**DEFENSE NUCLEAR FACILITIES
SAFETY BOARD**

Staff Report

Evaluation of Nuclear Operations and Maintenance Activities at the Defense Waste Processing Facility (DWPF)

Figure 2. Tipped Canister from March 2025 Event

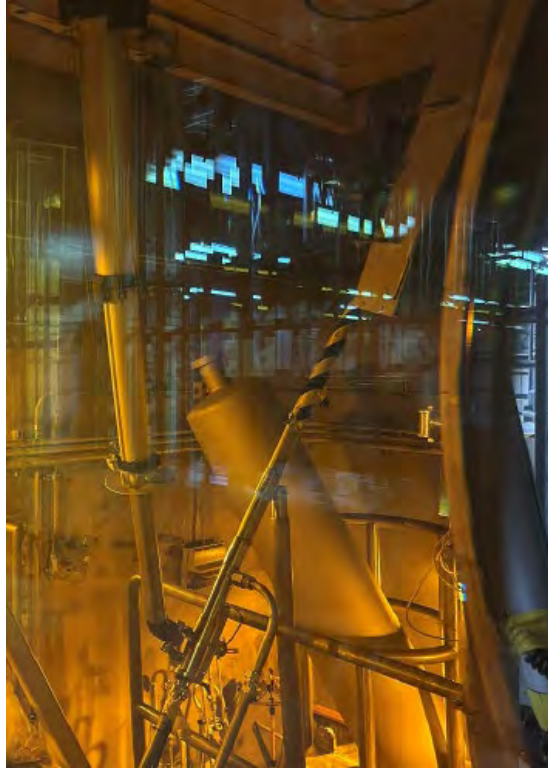
Evaluating Safety Culture to Gain Additional Insights for Performance Improvement—In March 2025, a tipped radioactive glass canister event highlighted persistent issues at DWPF. A first line manager (FLM) and operator, while attempting to move a filled canister into the weld test cell, mistakenly caused the 4500-pound canister to tip over, ultimately coming to rest at a 40° angle on a guard rail (Figure 2). The task requires two operators per the procedure, but only one (who had never performed the task) was assigned. Further, the procedure stated that a second operator should be stationed at the smear test station window to ensure proper grapple engagement, which was a lesson learned from a previous dropped canister event. When the operator requested assistance during the evolution, the FLM performed work rather than supervising and took over control of the crane to engage the grapple when the canister tipped over.

Contributing factors to this event align with the safety concerns identified by the staff team during this review, such as poor adherence to disciplined operations principles, facility material conditions, and training. During the issue investigation meeting, the FLM stated that operators routinely perform this operation solo. The workers also did not perform a pre-job brief, which is required. Visibility was limited due to out-of-service or poorly functioning cameras inside the cell. A review of training identified that the evolution was not explicitly covered in the training program and both individuals were relatively inexperienced in their roles.
